FINAL TECHNICAL MEMORANDUM GROUNDWATER AND VAPOR INTRUSION
INVESTIGATION FOR BUILDING 250 AND HANGAR 4 NAS BRUNSWICK ME
11/1/2013
TETRA TECH

Building 250 and Hangar 4
Former Naval Air Station Brunswick
Brunswick, Maine

November 2013

| FIGURE NUMBER | 2 | REV | DATE |

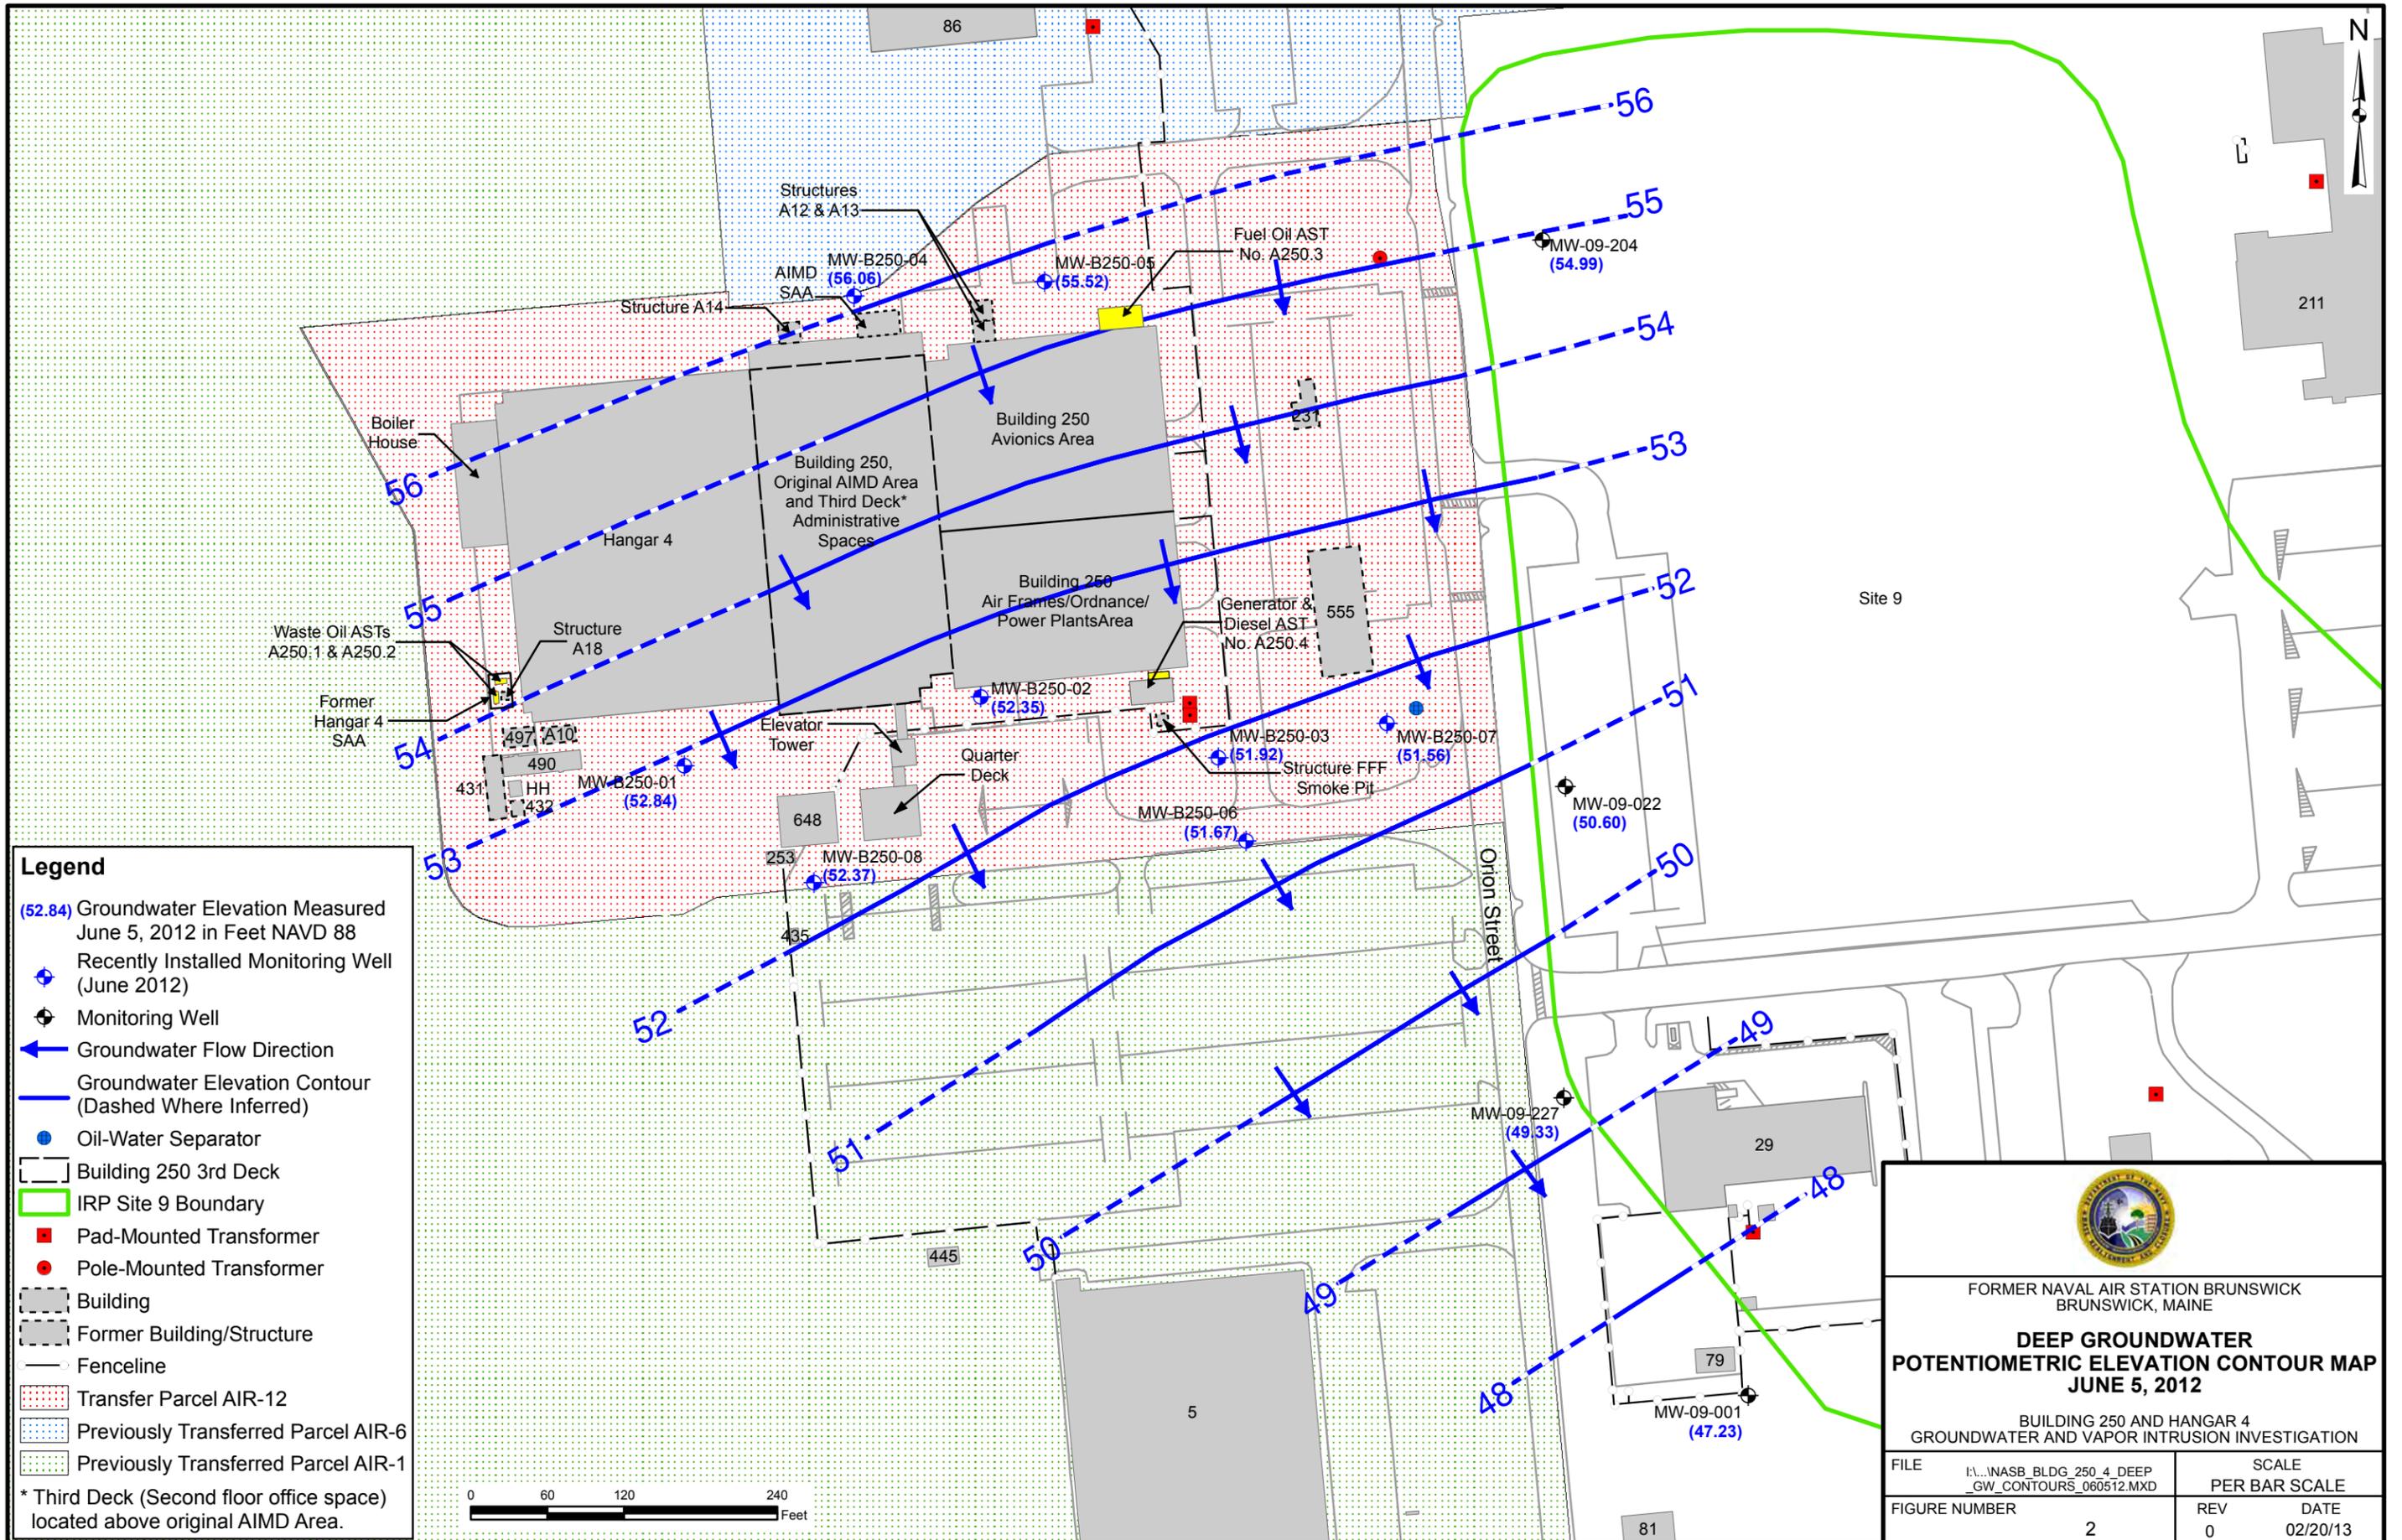
4. **Comment:** There is a distinction between Hangar 4 and Building 250 that needs to be maintained throughout the document. Figure 2 should be revised to clearly distinguish the two as the middle of the first floor of the structure is not clearly identified as Hangar 4 or as Building 250. Please check the document for accuracy, particularly Section 5.

Response: Figure 2 was revised to identify the middle of the structure as the Original Building 250 AIMD Area on the first floor and as the Third Deck Administrative Spaces on the second floor. In addition, references to Hangar 4 and Building 250 have been revised as necessary to accurately reflect the area being discussed.
